Table 1: Rainbow–San Diego (Line 3602) 36-inch Natural Gas Pipeline Project Application Deficiencies (October 30, 2015)

Figure 36: Adjusted Demand Scenarios for Natural Gas, SDG&E Service Territory

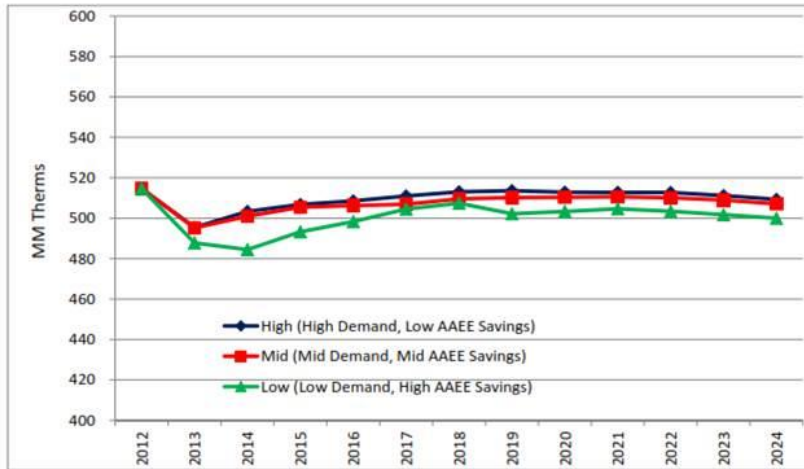
With the inclusion of Additional Achievable Energy Efficiency (AAEE) savings, the CEC does not forecast that natural gas demand will exceed 2012 levels in the next 10 years (CEC 2014, p. 75, Figure 36). Demand would equate to between -0.09 percent and -0.24 percent through 2024. The following chart or similar should be updated based on 2015 data for inclusion in the PEA. A discussion should be provided.

Solar and Gas Demand on July 2, 2015

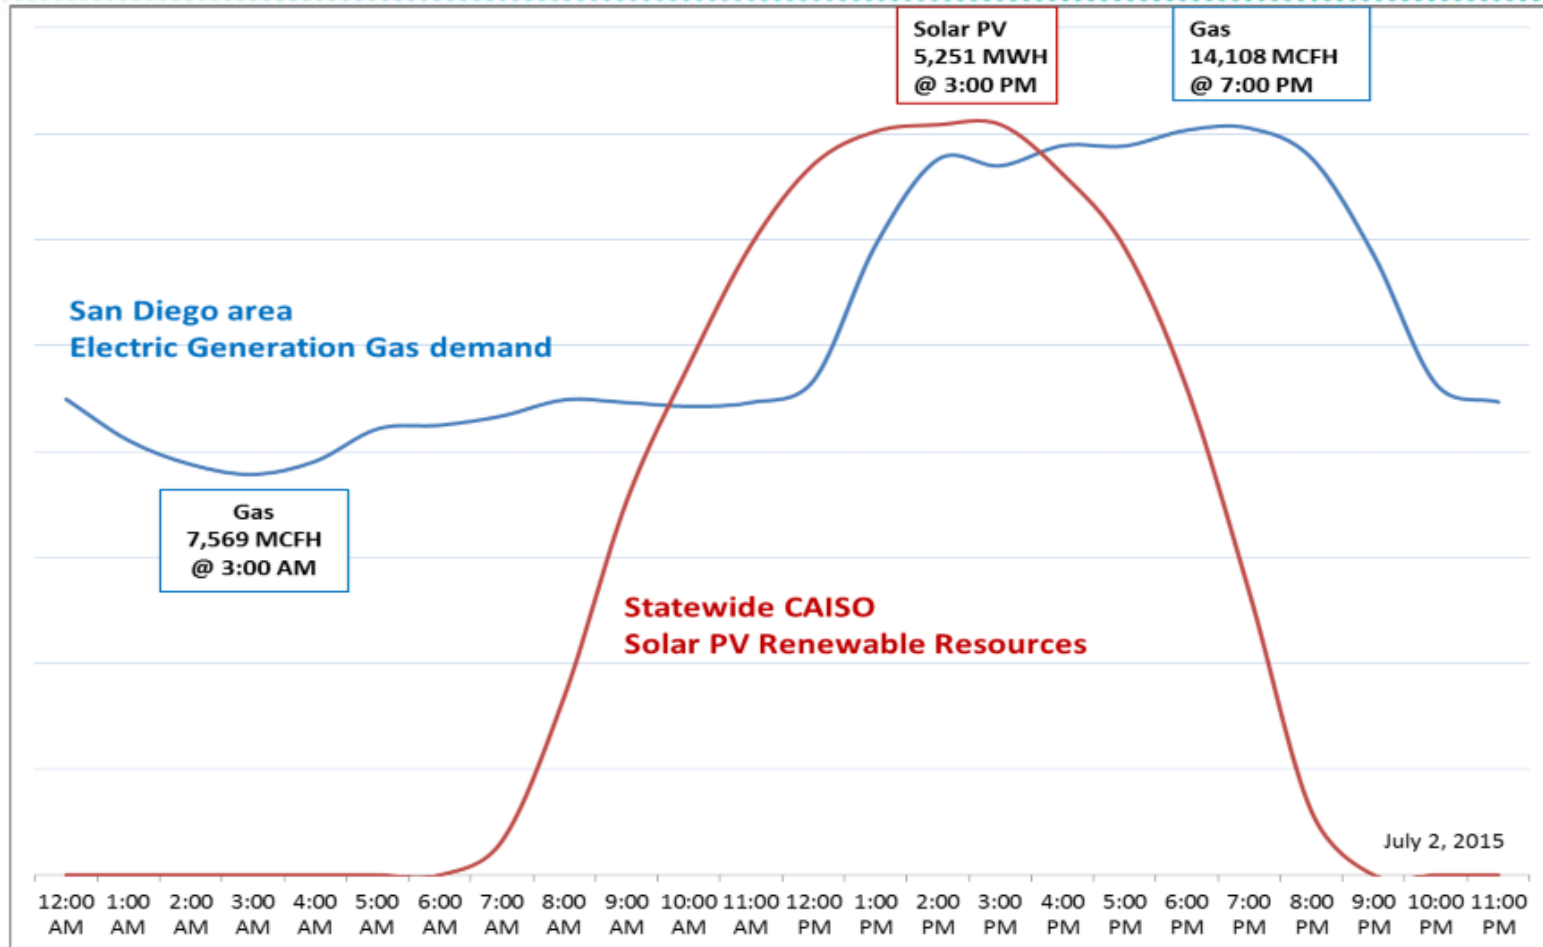
1.2-13	Purpose and Need / Alternatives	Ch. 2, 5	Provide an explanation of the increase (spike) in natural gas demand for electric generation on July 2, 2015 . Also provide a thorough discussion of this type of event with estimates of how often it has, and is expected to, occur. Include historical data of actual events and the resultant power loss to various types of customers as well as forecast data used to estimate the probability of reoccurrences. See attached slide presented to CPUC Energy Division management on 8/20/15.	10/30/15			See attached slide from 8/20/15 presentation to CPUC

Figure 36: Adjusted Demand Scenarios for Natural Gas, SDG&E Service Territory

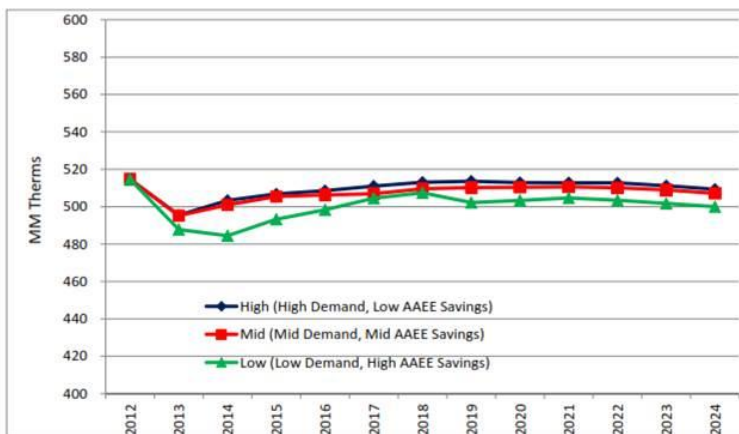
With the inclusion of Additional Achievable Energy Efficiency (AAEE) savings, the CEC does not forecast that natural gas demand will exceed 2012 levels in the next 10 years (CEC 2014, p. 75, Figure 36). Demand would equate to between -0.09 percent and -0.24 percent through 2024. The following chart or similar should be updated based on 2015 data for inclusion in the PEA. A discussion should be provided.
